SINGH ARCHITECTS & ASSOCIATES, INC. CONSULTING ENGINEERS	USER NAME * kprajapati	DESIGNED - RDP	REVISED 6/18/2013	STATE OF ILLINOIS DEPARTMENT OF TRANSPORTATION	STUENKEL ROAD OVER I-57 PROPOSED LIGHTING PLANS (SHEET 6 OF 7)	F.A.I. RTE. 57	SECTION 99-1HB-R	COUNTY WILL	TOTAL SHEETS 679	SHEET NO. 336
	PLOT SCALE * 100.00000001.000000	DRAWN - MG/WC	REVISED 8/22/2013			CONTRACT NO. 60L69				
	PLOT DATE * 26-DEC-2013 15:02	CHECKED - KCP	REVISED 10/18/2013			ILLINOIS FED. AID PROJECT				
	DATE - 8/22/2013	DATE - 12/04/2013	ADDENDUM 1 1/03/14

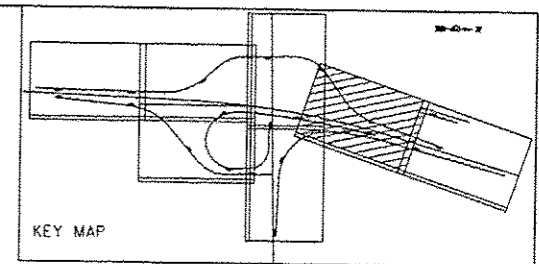
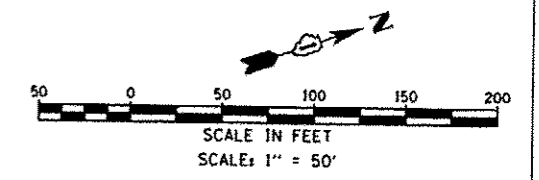
1. REMOVE THE TEMPORARY PROTECTION INSTALLED ON EXISTING TRANSFORMER BASE. REINSTALL EXISTING LIGHT POLE WITH NEW HARDWARE, NEW FUSE AND FUSE HOLDERS, NEW 310W HPS LAMP COMPLYING WITH THE ARTICLE 1067.06(g) OF STANDARD SPECIFICATION, AND NEW POLE DECAL. THIS WORK SHALL BE INCLUDED AS PART OF THE PAY ITEM "RELOCATE LIGHTING UNITS".
